APPLICATION NO.	FILING DATE	FIRST NAMED INVENTOR	ATTORNEY DOCKET NO.	CONFIRMATION NO.
10/603,653	06/26/2003	Bo Carlstrom	024445-354	4028
55694 7	590 02/23/2006		EXAM	INER
DRINKER BIDDLE & REATH (DC)			GAY, JENNIFER HAWKINS	
1500 K STREET, N.W. SUITE 1100 WASHINGTON, DC 20005-1209			ART UNIT	PAPER NUMBER
			3672

Application No.	Applicant(s)				
	10/603,653	CARLSTROM ET AL.				
Office Action Summary	Examiner	Art Unit				
	Jennifer H. Gay	3672				
The MAILING DATE of this communication appears on the cover sheet with the correspondence address Period for Reply						
A SHORTENED STATUTORY PERIOD FOR REPLY IS SET TO EXPIRE 3 MONTH(S) OR THIRTY (30) DAYS, WHICHEVER IS LONGER, FROM THE MAILING DATE OF THIS COMMUNICATION. - Extensions of time may be available under the provisions of 37 CFR 1.136(a). In no event, however, may a reply be timely filed after SIX (6) MONTHS from the mailing date of this communication. - If NO period for reply is specified above, the maximum statutory period will apply and will expire SIX (6) MONTHS from the mailing date of this communication. - Failure to reply within the set or extended period for reply will, by statute, cause the application to become ABANDO

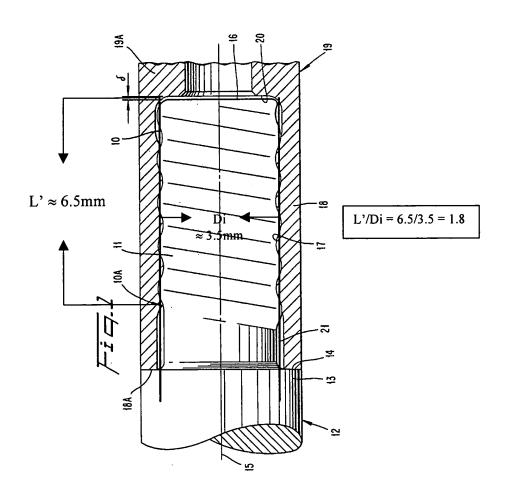
- A central recess (Figure 1) having an internal thread 17 provided along a portion of the recess.
- An abutment surface 20 at an inner end of the recess.
- A length L' defined from the abutment surface to a point where an imaginary coaxial circular cylinder ceases to contact a crest of the thread. The quotient of L' divided by the diameter Di of the imaginary

cylinder is within the range of 1-2 (see included figure). (The examiner recognizes that Larsson neither specifically teaches or shows this feature but notes that a measurement of Figure 1 shows that L' can be taken to be approximately 6.5 mm and Di can be taken to be approximately 3.5 mm. While drawings cannot be considered to scale, the ratio of the dimension of two parts is considered to be a value that will not change when the scale of the figures is.)

Regarding claims 8, 10: The quotient is approximately 1.8, which is considered to encompass 1.6.
